RE: ENGINEER'S CERTIFICATION FOR MCDONALD'S @ LOMAS & JUAN TABO (K-21/D26)
ENGINEER'S STAMP DATED JAN 11, 1994; RECEIVED JANUARY 12, 1994
FOR CERTIFICATE OF OCCUPANCY APPROVAL

RE: GRADING & DRAINAGE PLAN FOR MCDONALD'S @ LOMAS & JUAN TABO (K-21/D26)
ENGINEER'S STAMP DATED 8-17-93; RECEIVED AUGUST 17, 1993
FOR BUILDING PERMIT APPROVAL

RE: ENGINEER'S CERTIFICATION FOR MCDONALD'S @ LOMAS & JUAN TABO (K-21/D26)
ENGINEER'S STAMP DATED DEC. 7, 1993; RECEIVED DECEMBER 7, 1993
FOR CERTIFICATE OF OCCUPANCY APPROVAL

McDonald's
11824 LOMAS BLVD. N.E.

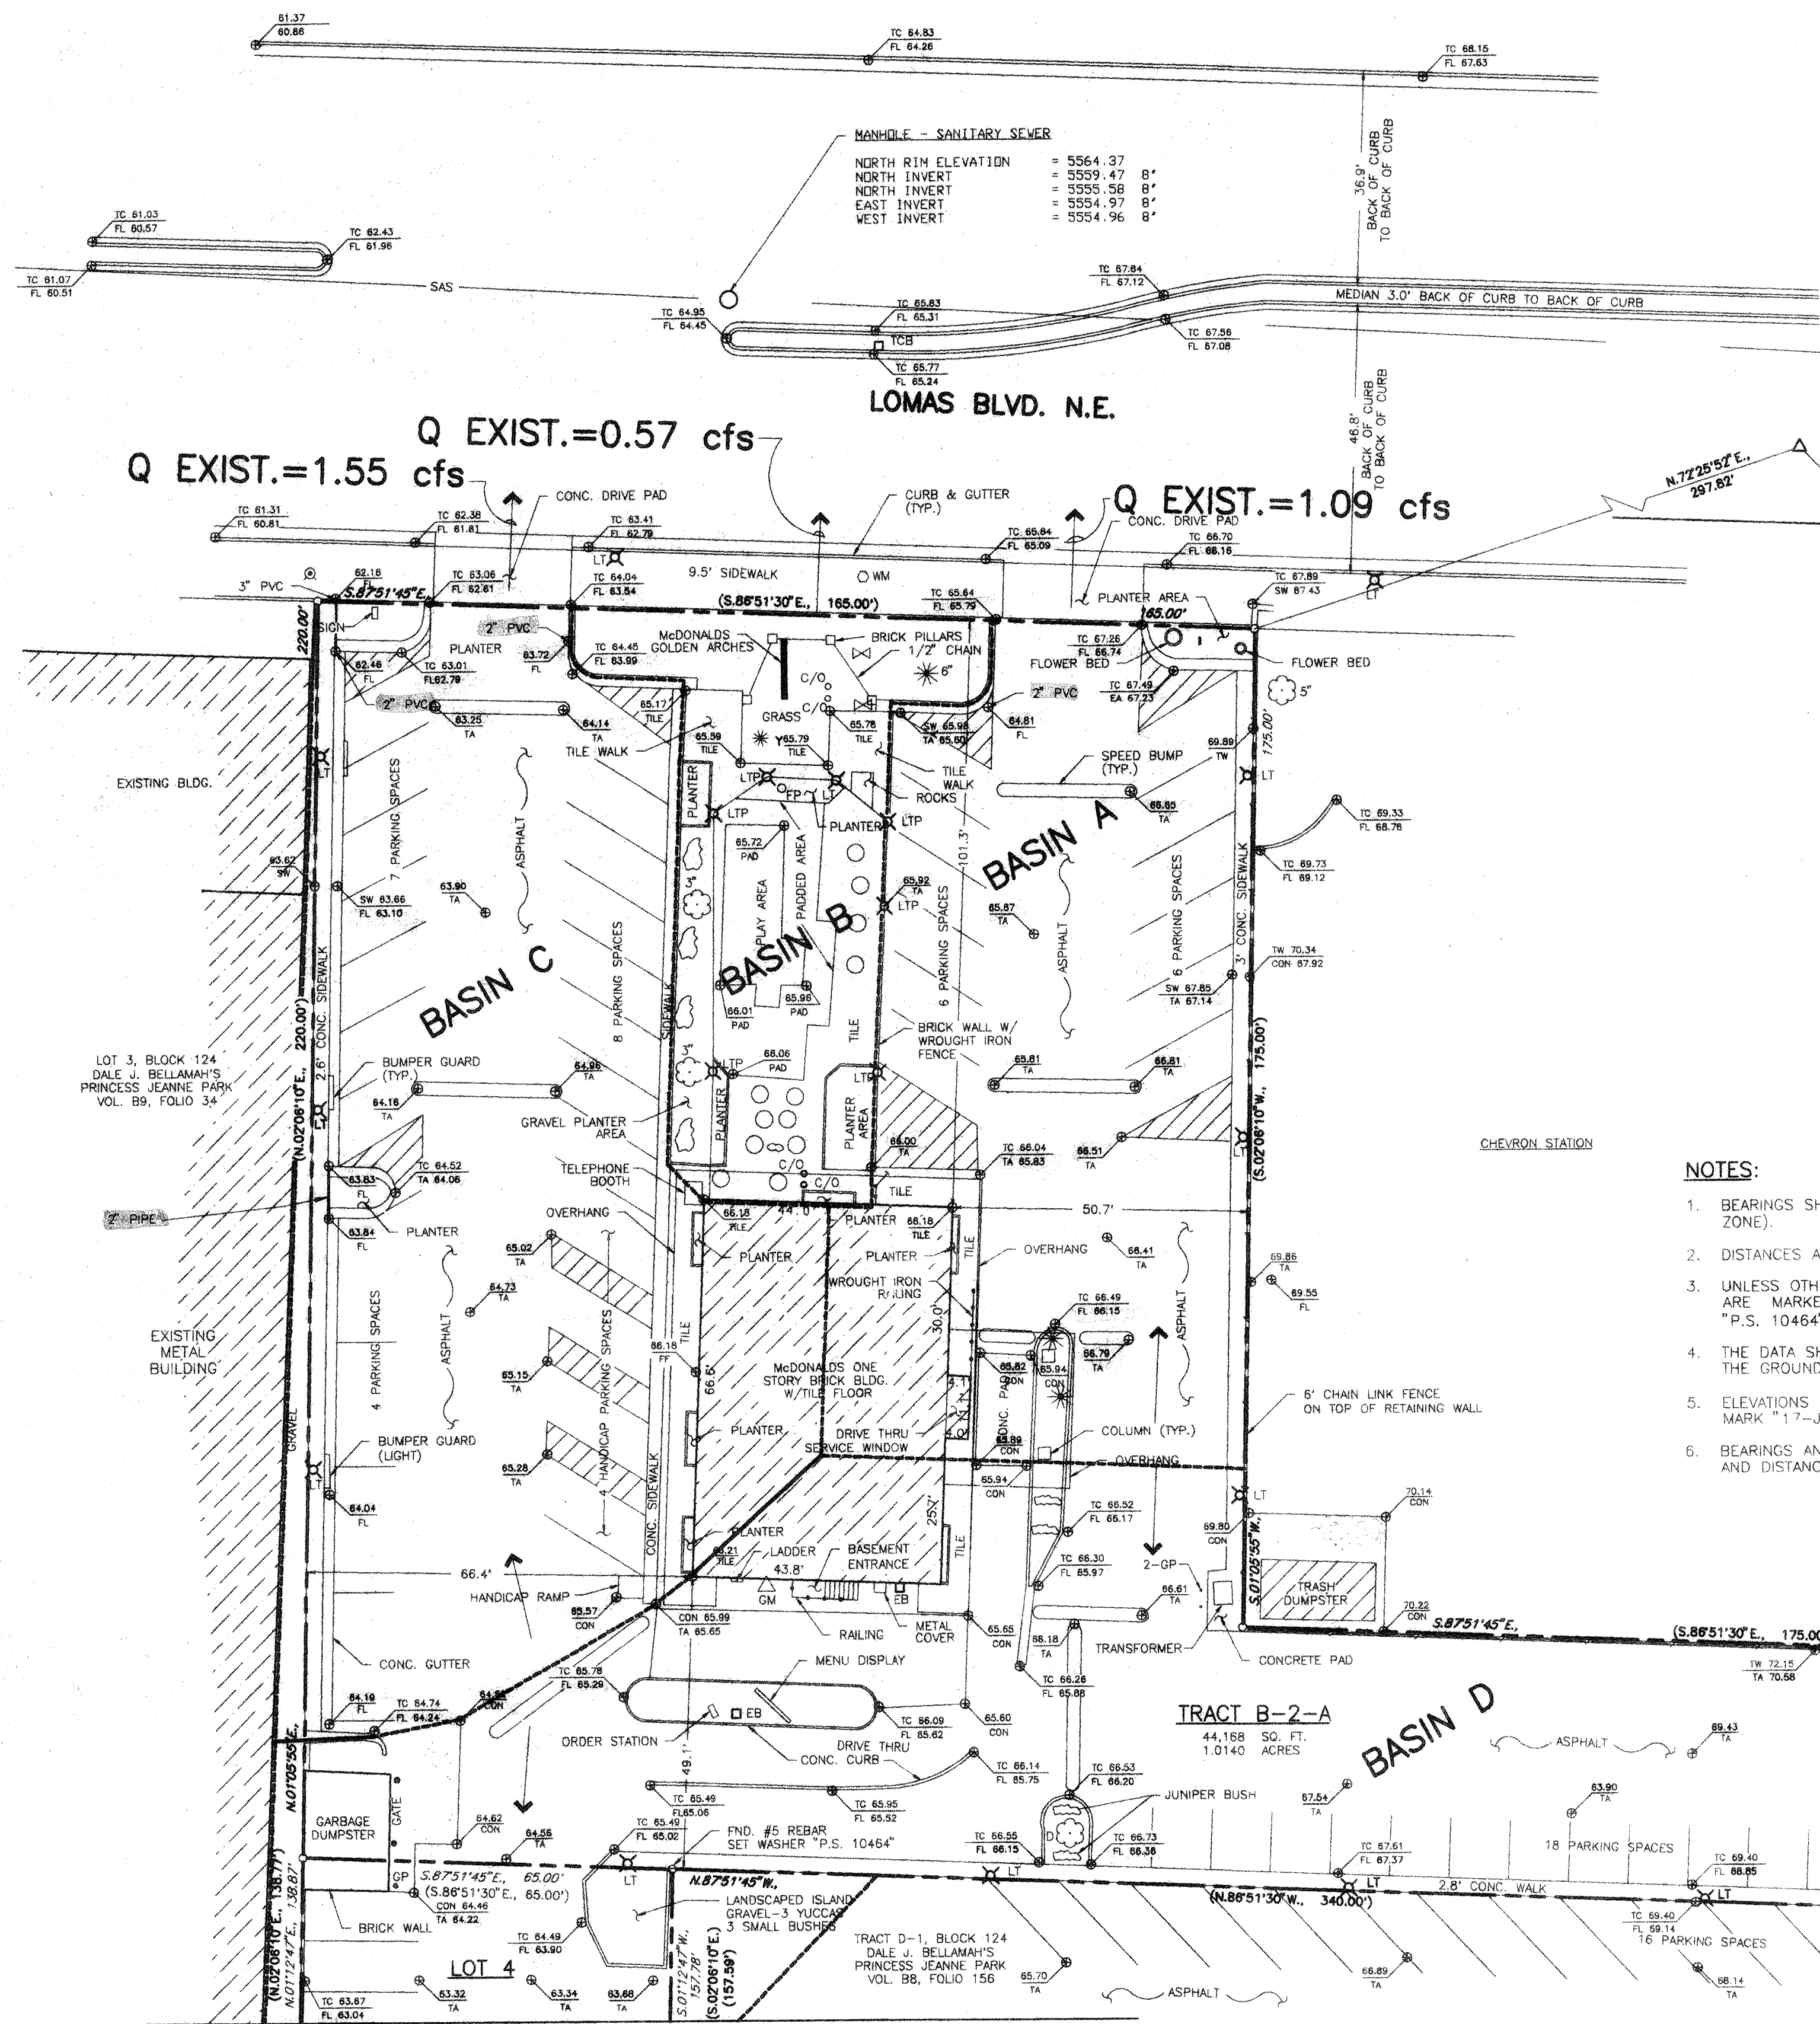
Fred said to go ahead & give them a Temp C.O. for 30 days.

C1

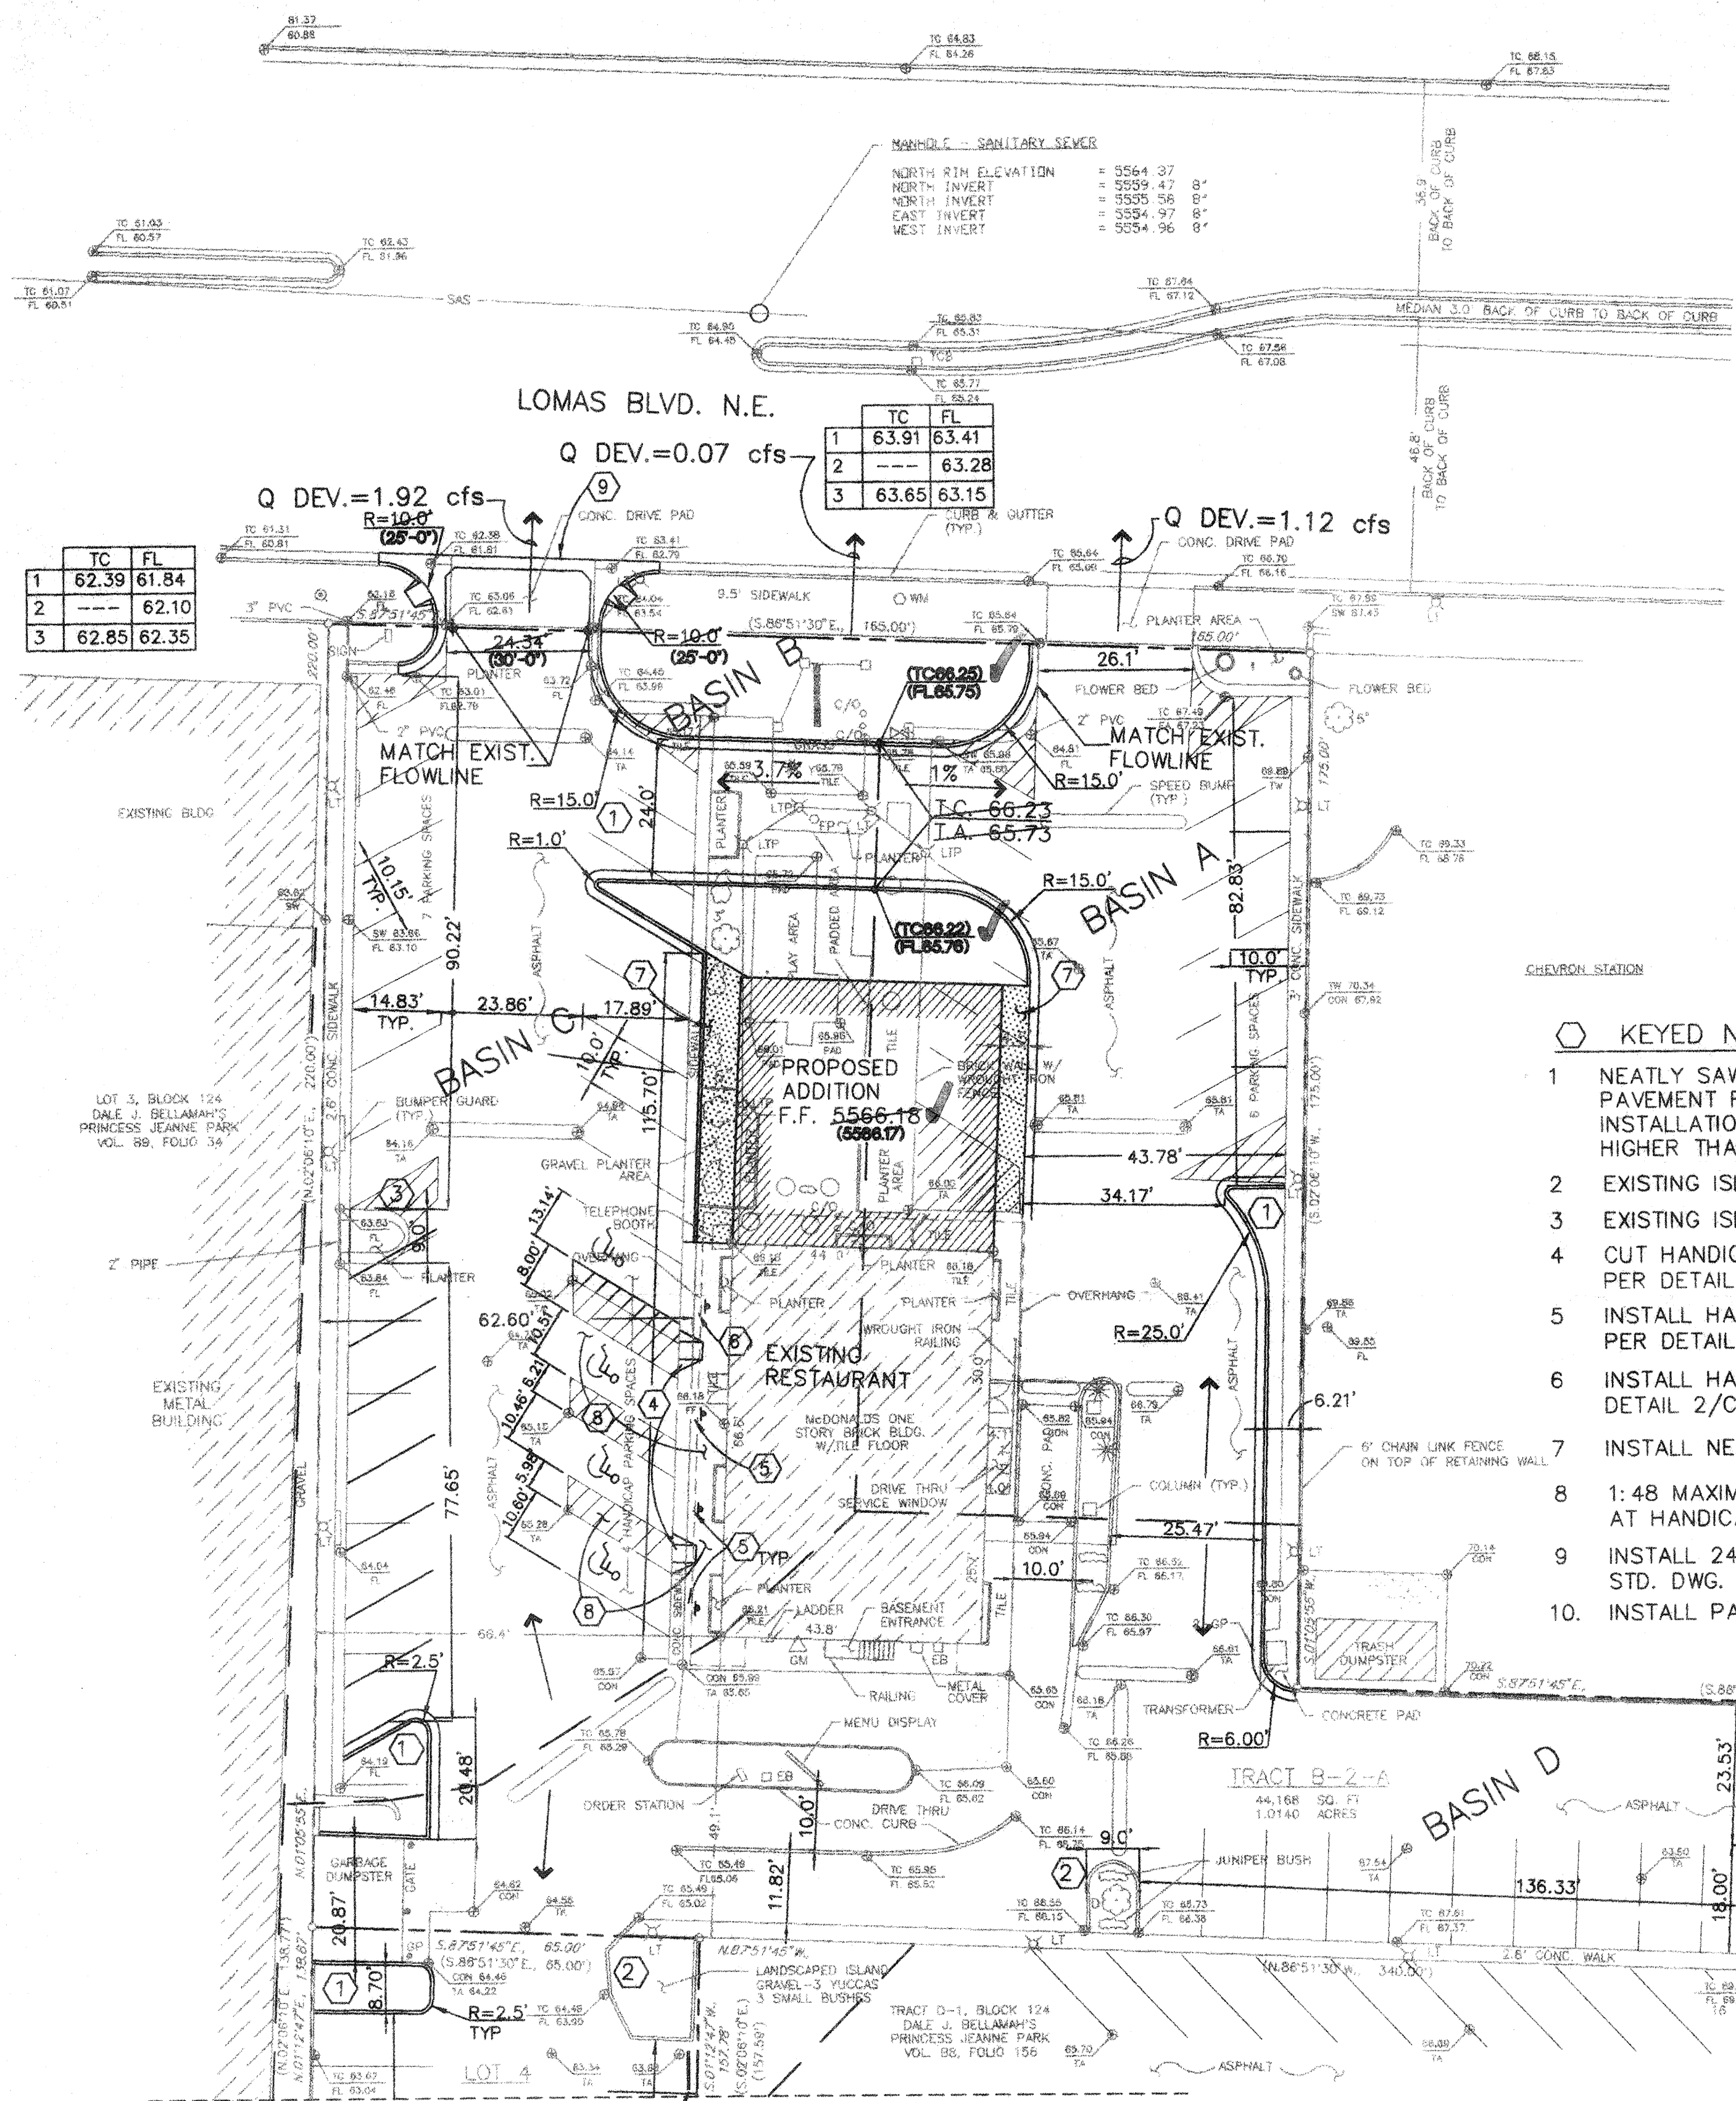
The Certification of compliance statement must be on the drawing instead of in a letter. As-Built elevations must be provided for the Finished Floor and any other proposed elevations. City Hydrology prefers that you cross out the proposed elevation and write the as-built elevation next to it so that any change can be evaluated. If the as-built elevation matches the proposed elevation exactly then a check mark is sufficient. Include As-Built elevations in the Legend.

When a copy of the executed & recorded Drainage/Access Easement is submitted to City Hydrology, then a permanent Certificate of Occupancy will be released.

- FLOW ARROW
- BASIN BOUNDARY
- Q DEV.=1.09 cfs → DEVELOPED BASIN DISCHARGE
- ▨ NEW BUILDING
- NEW CURB
- T.C. 66.23 T.A. 65.73 NEW TOP OF CURB/FLOWLINE
- ▨ NEW SIDEWALK
- c DESIGNATED COMPACT CAR PARKING
- T.C. 66.23 (T.C. 66.22) AS-BUILT ELEVATIONS

TRACT-1-A
ACCESS AND DRAINAGE EASEMENT
RECORDED ON JANUARY 10, 1994
BOOK 94-1, PAGE 8186-8192.

I HEREBY CERTIFY THIS DRAINAGE PLAN IS IN SUBSTANTIAL COMPLIANCE WITH THE APPROVED DRAINAGE PLAN.
SIGNED: *Joe P. Kelley* PE#9996
DATE: *Jan 11, 1994*
